Project	IEEE 802.16 Broadband Wireless Access Working Group <a href="http://ieee802.org/16">http://ieee802.org/16</a> >		
Title	The way for forcing all SSs to be reset		
Date Submitted	2005-07-10		
Source(s)	Yeongmoon Son, Jungje Son, Panyuh Joo	Voice: +82-31-279-5845 FAX.:+82-31-279-5130	
	Samsung Electronics Co. Ltd.	ym1004.son@samsung.com jungje.son@samsung.com	
Re:	IEEE P802.16-2004/Cor1/D3		
Abstract	This contribution proposes the scheme for forcing all SSs to be reset at once		
Purpose	Discuss and adopt this contribution		
Notice	This document has been prepared to assist IEEE 802.16. It is offered as a basis for discussion and is not binding on the contributing individual(s) or organization(s). The material in this document is subject to change in form and content after further study. The contributor(s) reserve(s) the right to add, amend or withdraw material contained herein.		
Release	The contributor grants a free, irrevocable license to the IEEE to incorporate material contained in this contribution, and any modifications thereof, in the creation of an IEEE Standards publication; to copyright in the IEEE's name any IEEE Standards publication even though it may include porti

Figure 1 - The Operation by Restart Count TLV encoding in DCD message

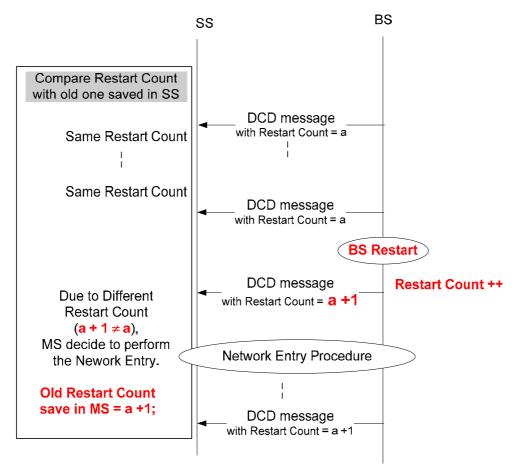
We propose the restart count TLV encoding which is included in DCD message.

- Restart Count sent by BS:
  - The restart count means the number of times in which BS restarts. This restart count is incremented by one whenever BS restarts. The restart count as TLV encoding is included in DCD message
- Restart Count saved in SS:

The restart count, which BS sent via DCD message, is saved in SS in order to recognize whether BS restarts or not. Whenever SS receives DCD message from BS, it compare the restart count in DCD message with the old one saved in it. As a result, if SS detects the restart count in DCD message is different from the old one, SS decides to perform the Network Entry. Therefore, SS updates the old restart count with the restart count in DCD message and performs the Network Entry

Figure 1 shows the operation by BS Restart Count TLV encoding in DCD message
